FACILITY: South Texas Project, Units 1 and 2

SUBJECT: SUMMARY OF MEETING HELD ON OCTOBER 25, 1985 TO DISCUSS THE
EMERGENCY MANAGEMENT PLAN

Review Comments On The South Texas Project Electric Generating
Station Emergency Plan (December 26, 1984)

EMERGENCY OPERATIONS CENTER ORGANIZATION

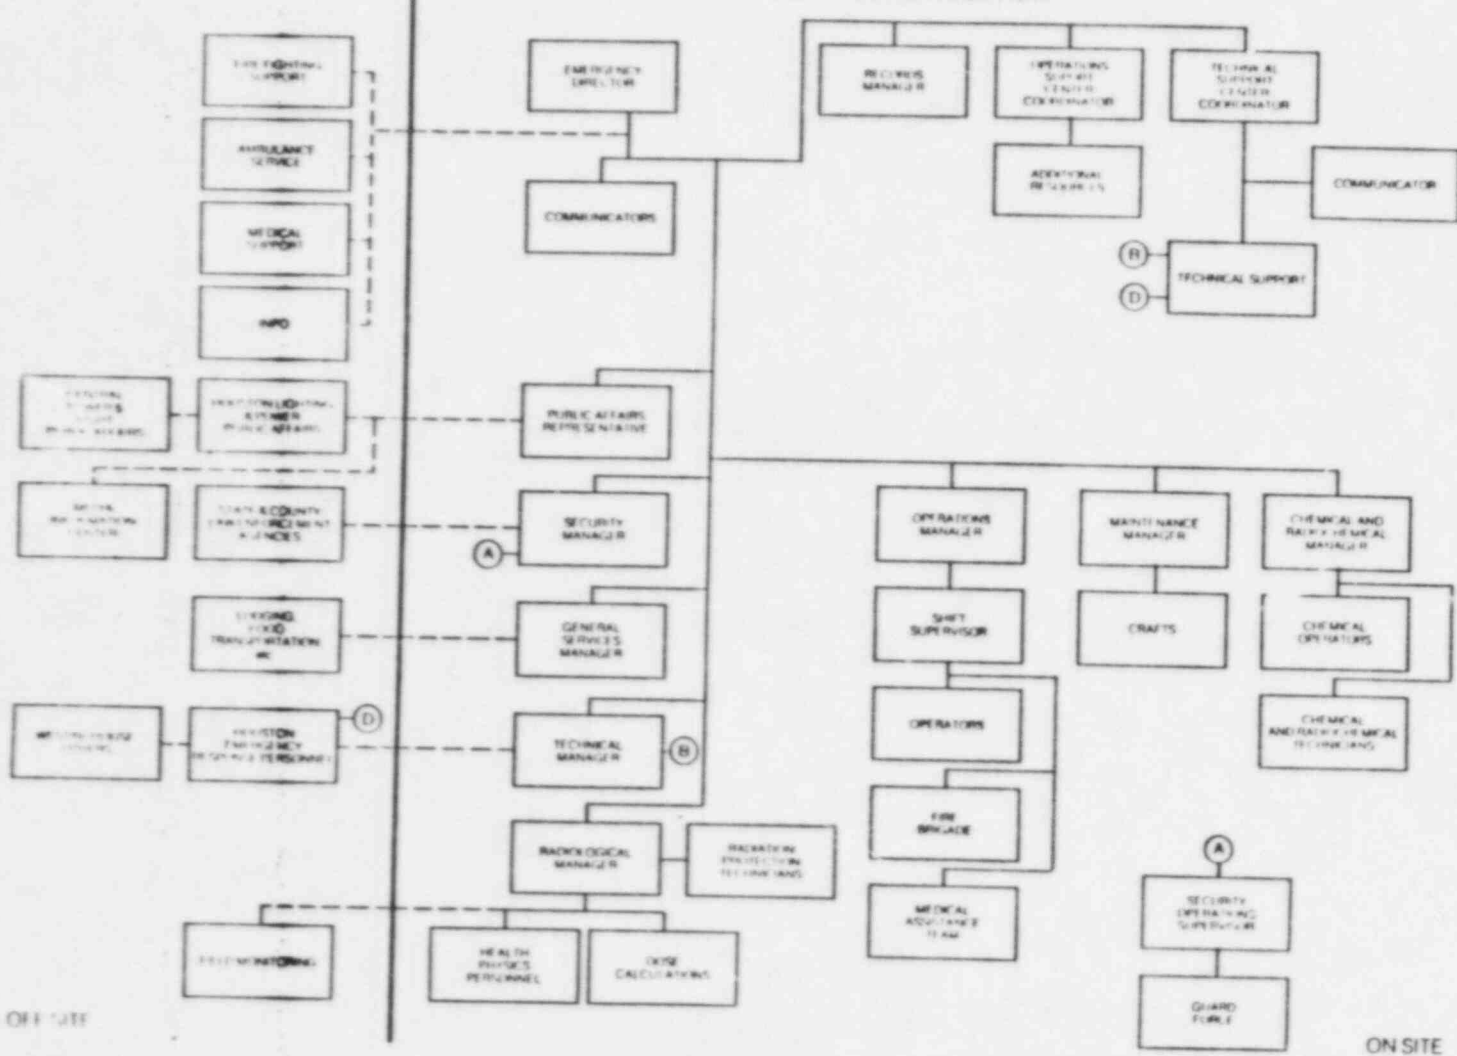
1. The plan specifies the onsite emergency organization; however in Figure 9.2 this organization appears to be rather unwieldy in that 12 managers report directly to the Emergency Director. In addition duties are assigned to a Radiological Services Manager and it is unclear as to whether this is the Radiological Manager or some other individual not covered in the functional descriptions in the plan. (B.1 and B.2)

6. The plan does not specify adequately the interfaces between and among the onsite functional areas of emergency activity, HL&P in Houston and the state and local emergency organizations to determine if they will be effective. The diagram in Figure 9.2 is incomplete in that it does not illustrate all the Federal, state and local emergency organizations involved in the response. (B.6)
7. The plan does not provide copies of the arrangements and agreements with contractor, private and local support agencies and the authorities, responsibilities and limits on actions of these organizations are not clearly delineated. (B.9)
